Model: Cattleya		Date: 30-Jun-99	No.: MA257001
Modified Article: Silicone oil		Prepared by: H. Matsui	
From: Technical Service Dept., GTS Division			
Reason for Modification:	☐ Parts catalog correction ☐ To facilitate assembly ☐ Part standardization	☐ Vendor change ☐ To improve reliability ☒ Other	☐ To meet standards ()

Model: Cattleya		Date: 15-Aug-99	No.: MA257002
Modified Article: Main Board and Scanner IPU Board		Prepared by: H. Matsui	
From: Technical Service Dept., GTS Division			
Reason for Modification:	☐ Parts catalog correction ☐ To facilitate assembly ☐ Part standardization	☐ Vendor change ☐ To improve reliability ☒ Other	☐ To meet standards ()

Model: Cattleya		Date: 30-Apr-99	No.: MA257003
Modified Article: Timing Belt		Prepared by: H. Mastui	
From: Technical Service Dept., GTS Division			
Reason for Modification:	☐ Parts catalog correction ☐ To facilitate assembly ☐ Part standardization	☐ Vendor change ☒ To improve reliability ☐ Other	☐ To meet standards ()

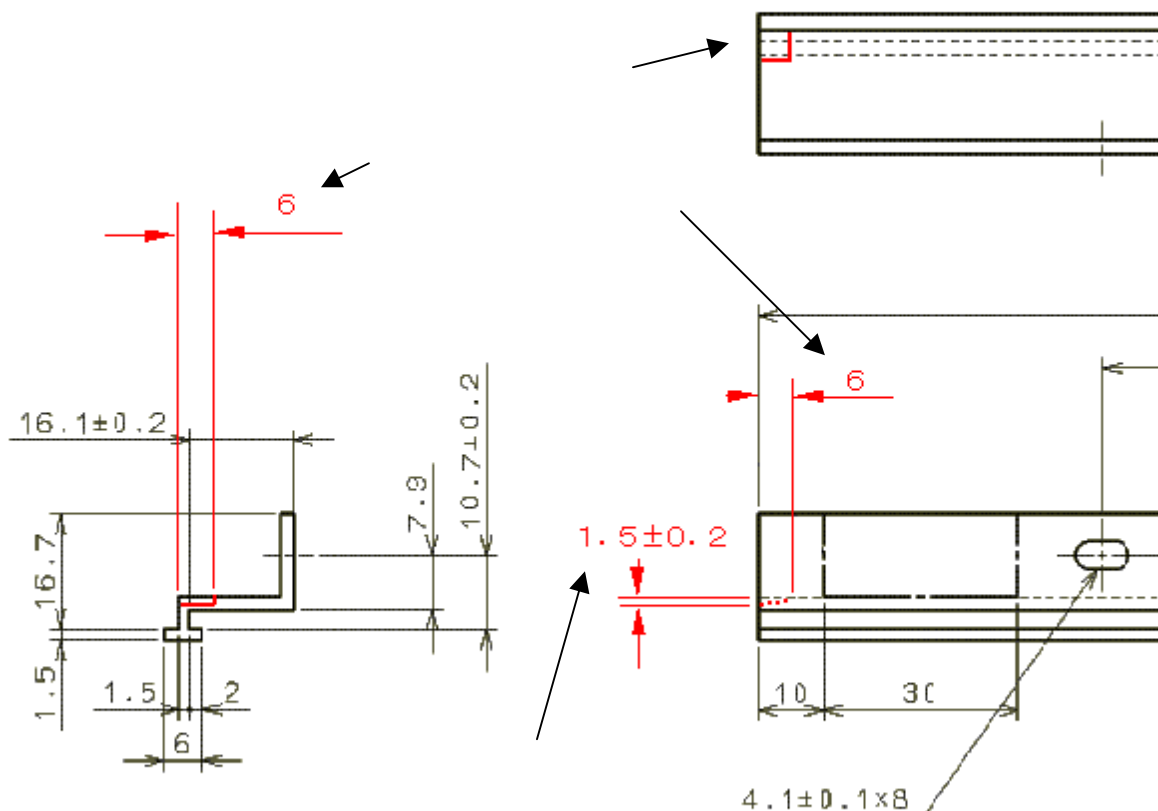
During assembly, the discharge corona unit can inhibit the installation of other machine parts. Therefore to facilitate assembly, the shape of the discharge corona rail has been changed as shown below. The portions highlighted in red (6, 6, 1.5±0.2) have been removed.

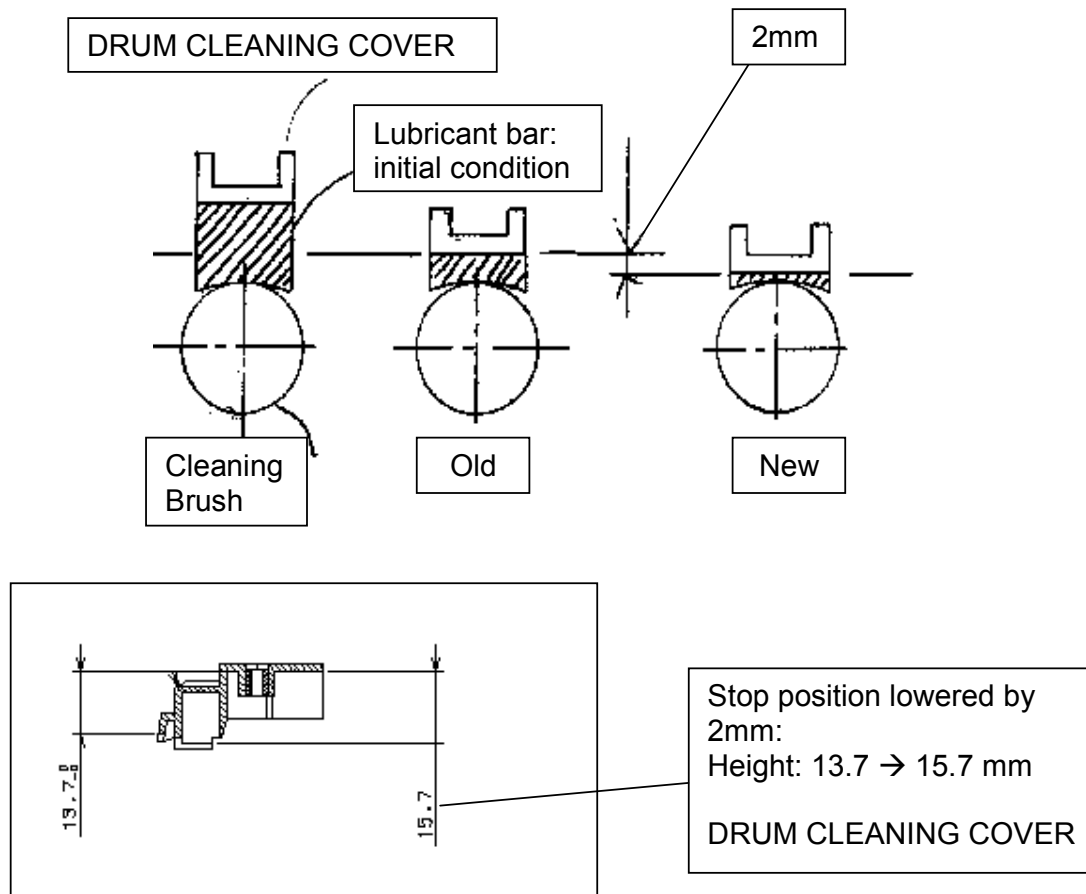
After the drum lubricant bar reaches a thickness of 2mm, noise is sometimes generated from the cleaning blade. To ensure that the lubricant bar is properly pressed against the cleaning brush, the stop position of the drum cleaning cover has been lowered by 2mm.

This will allow for a constant application to the brush, even if the height of the lubricant bar is less than 2mm.

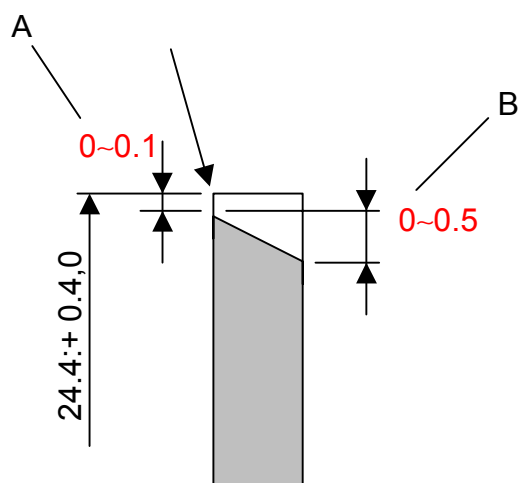
It was found in laboratory tests that oil lines can sometimes appear on the front and rear edges of the copy paper. To ensure proper image quality, specifications have been placed on cross-sectional dimensions A and B shown below (at both ends of the blade).

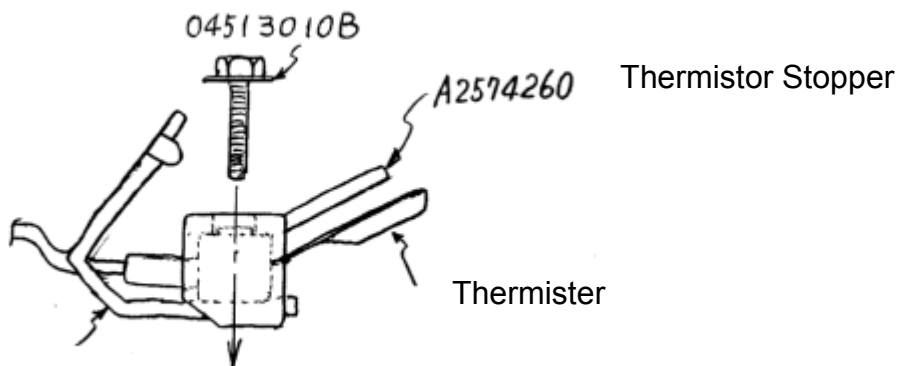
The hot roller thermistor may lift up during the copy process, which may cause a paper jam in the fusing section. To ensure proper paper feed, a thermistor stopper has been added to the fusing unit. The unit has been given a new P/N and the thermistor stopper has been registered as an individual service part.

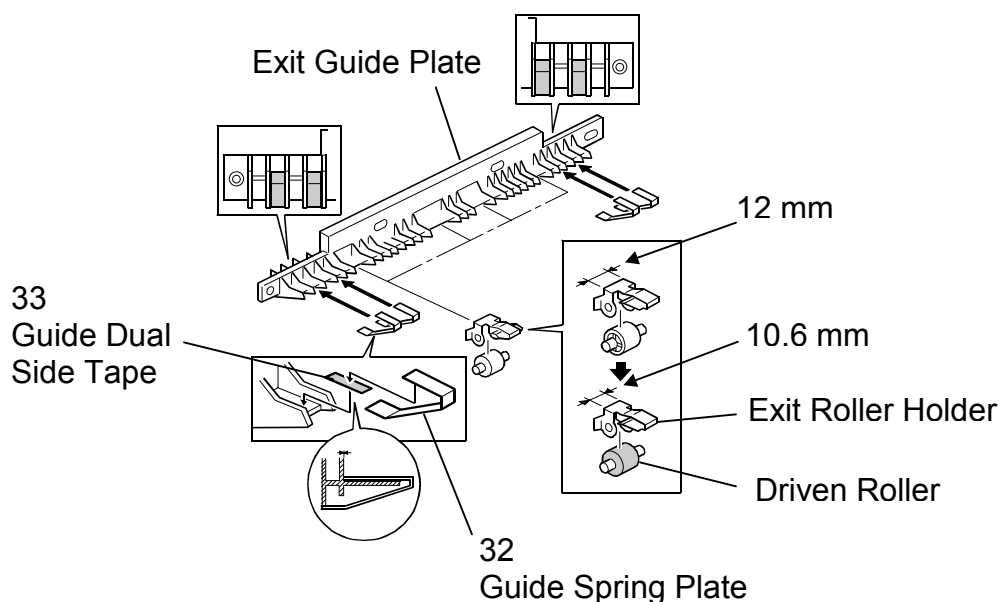
It was reported from the field in Japan that paper sometimes gets caught in the exit guide plate gap. To ensure proper paper feed, 4 guide spring plates and 4 pieces of guide dual side tape are added to the exit guide plate during machine assembly.

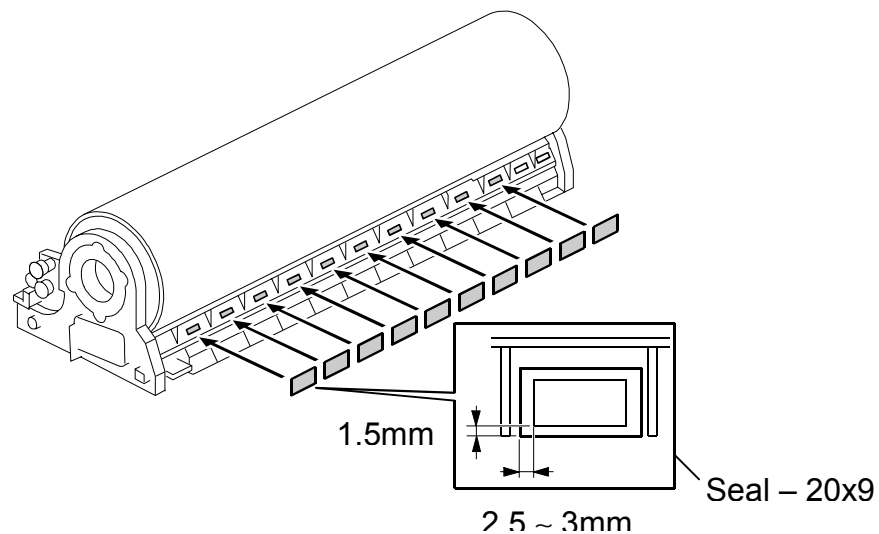
During laboratory tests, it was found that small amounts of toner can sometimes leak out of the development unit and stick to the toner shield glass. To ensure good copy quality, 11 seals have been added to cover the holes of the upper development duct.

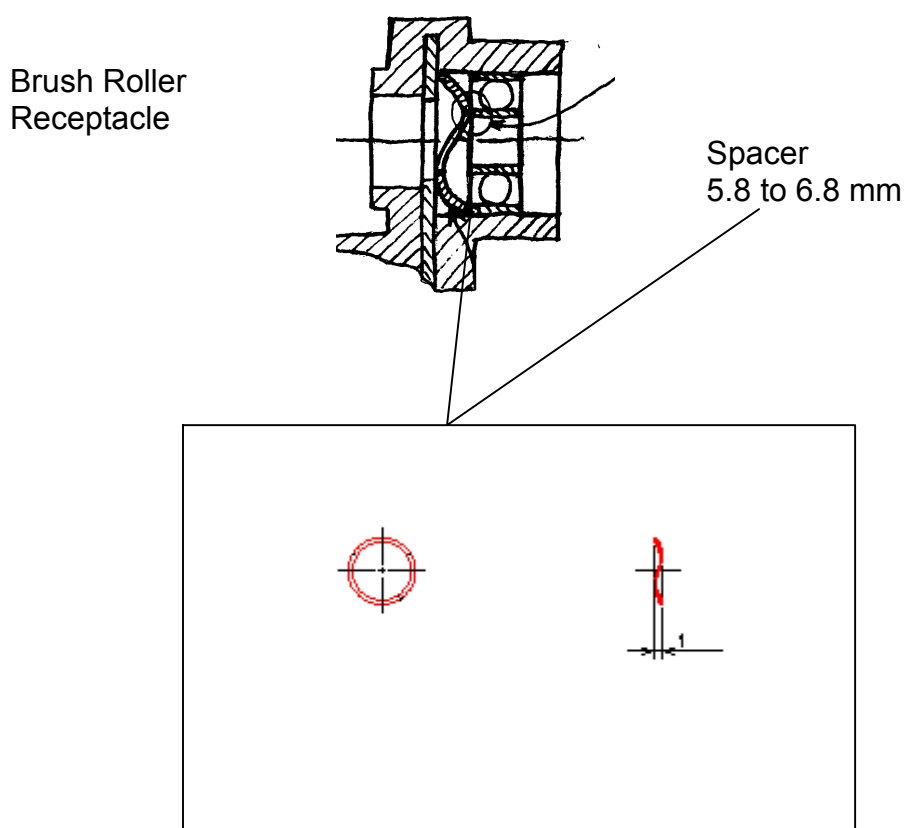
A noise may be generated from the spacer press-fitted in the brush roller receptacle. It was found that the spacer may contact the bearing in the brush roller receptacle. To correct this, the inner diameter of the spacer has been changed from 5.8 to 6.8 mm.

2. Exterior 2 (A257/A269)

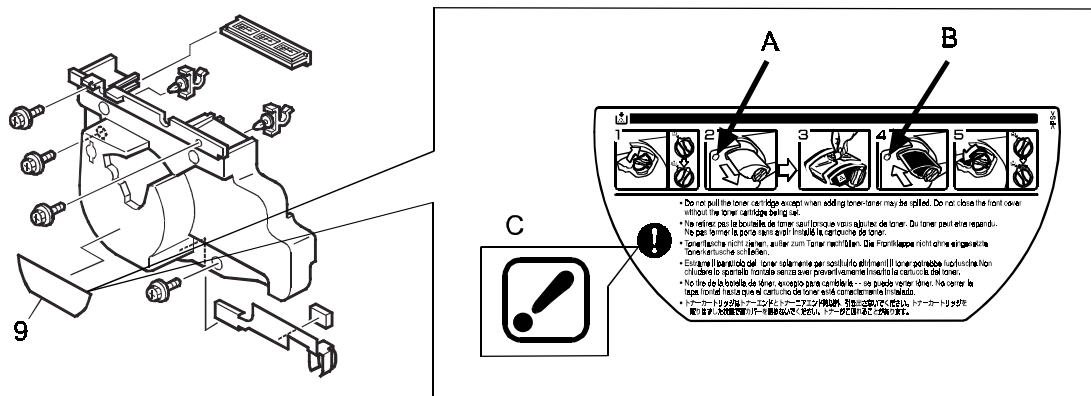
To prevent potential user operation mistakes, 2 illustrations on the toner replenishment decal [A and B below] have been removed, and the caution mark [C] has been slightly modified.

22. DRUM CLEANING UNIT (A257/269)

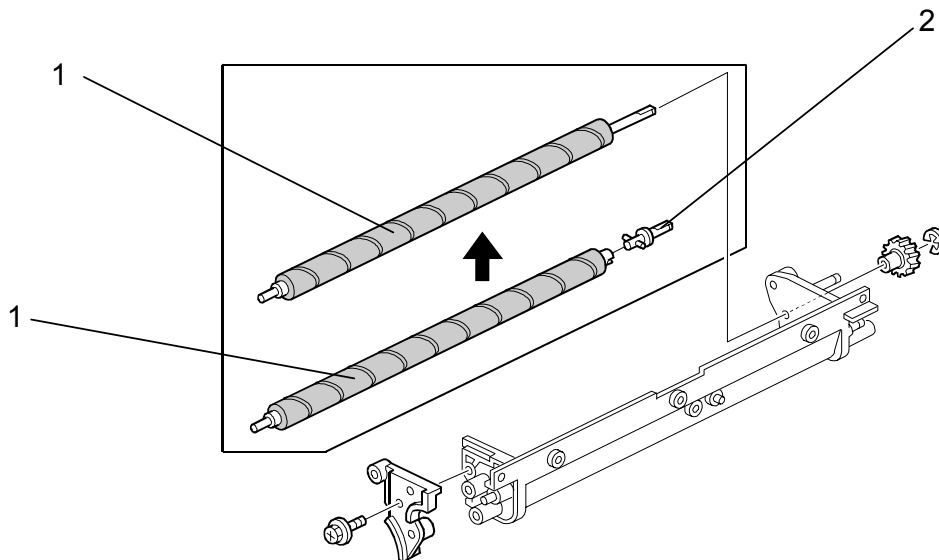
The Drive Shaft for the Drum Cleaning Brush can sometimes get scraped by the e-ring, which causes insufficient drive to be transferred to the brush. To continually ensure proper drive transfer, the Drive Shaft has been made part of the Drum Cleaning Brush.

27. Transfer Belt Unit (A257/A269)

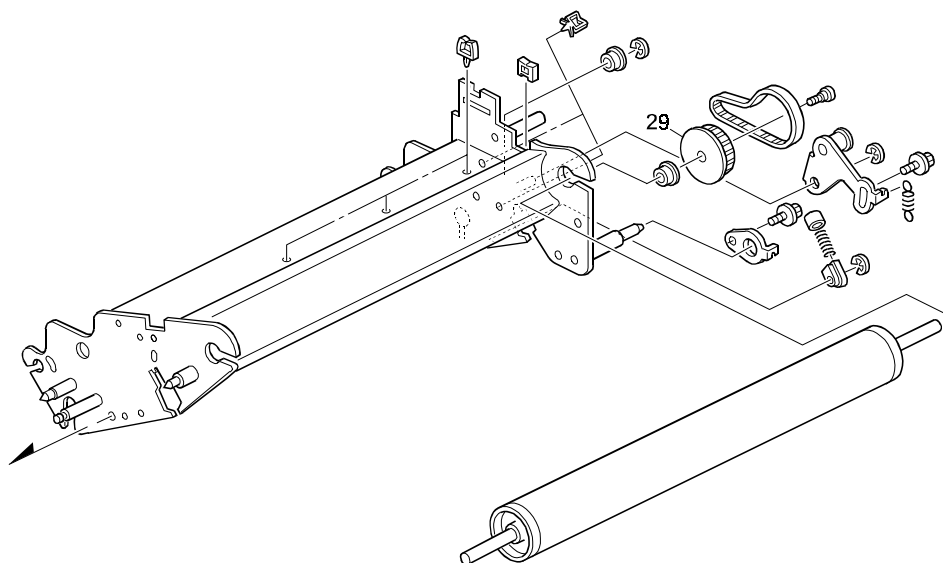
To prevent the timing belt from riding up on the collar, the tolerance of the gear has been made smaller.

27. TRANSFER BELT UNIT (A257/A269)

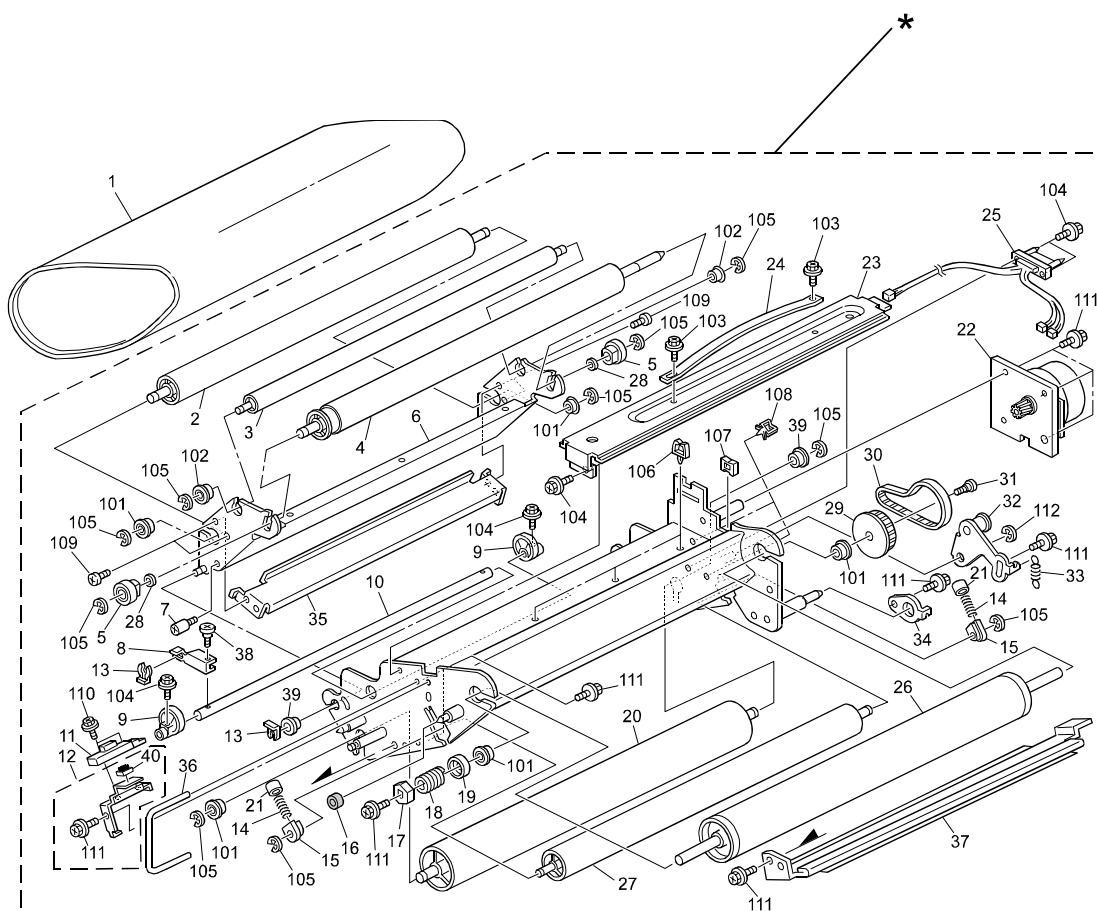
The corrected point: The dotted line around the ITB unit assembly that excludes the Transfer Belt is added. This is because the ITB unit assembly does not include the belt.

34. FUSING UNIT 1 (A257/A269)

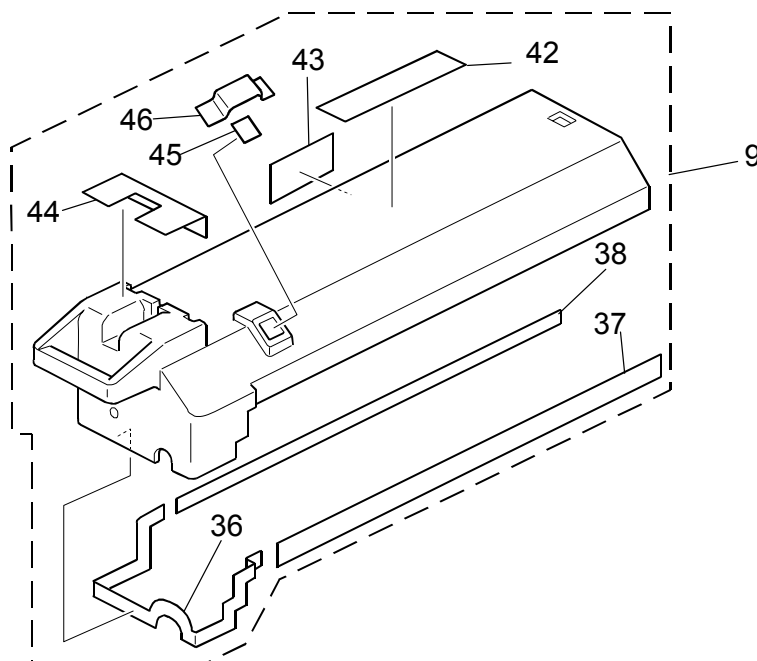
Note: The shape of the Fusing Cover has been slightly modified.
